**TO:** Wiaan Kruger and Cyril Mitchell,  
**FROM:** Lloyd Madge,  
**SUBJECT:** Foothills Regional Airport Fire Protection Pond – Prelim Report Questions  
**DATE:** February 19, 2026

On behalf of Foothills County (FC), WSP Canada Inc. (WSP) has prepared this technical memorandum to formally address questions arising from Council’s review of the Foothills Regional Airport Fire Protection Pond Preliminary Design Report dated November 2025.

**Figure 1 – Revised Location of Pond**

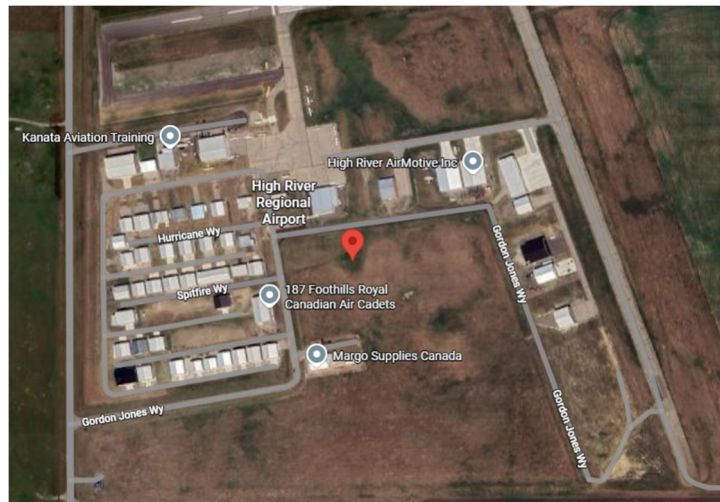
**Relocate the firewater pond to an existing wetland, as shown in Figure 1 below. The idea was that placing the pond in a natural drainage area would allow it to fill through overland drainage, potentially reducing the dependency on potable water from the Cayley line.**

- 1** The selected site is a localized low area lacking sufficient upstream catchment to generate sufficient surface water volume, so meaningful water savings would not be realized. The most reliable solution for a sustainable, year-round fire protection water supply at FRA remains connecting to the Cayley water line. Locating the reservoir closer to the Cayley water line will be more cost effective.

- 2 The proposed location falls within a future airside development phase designated for private hangar lots, which could negatively affect airport development plans. By comparison, the current pond location is in a future groundside development that are not directly related to the airport development and does not negatively impact future development of the airport.

- 3 Water quality and contamination are concerns. Airport runoff will contain sediment, hydrocarbons, and heavy metals; the greatest risk comes from possible fuel or chemical spills. The planned fire protection pond includes an earthen berm to protect it from surface runoff contamination.
- 4 We want to avoid providing a body of water within the airside development of the airport that would encourage wildlife especially water fowl from taking up residence at the airport.

Therefore, for the reasons discussed above WSP does not recommend considering relocating the pond as it does not meet the design intent to provide a permanent, year round water source for fire protection at the airport.
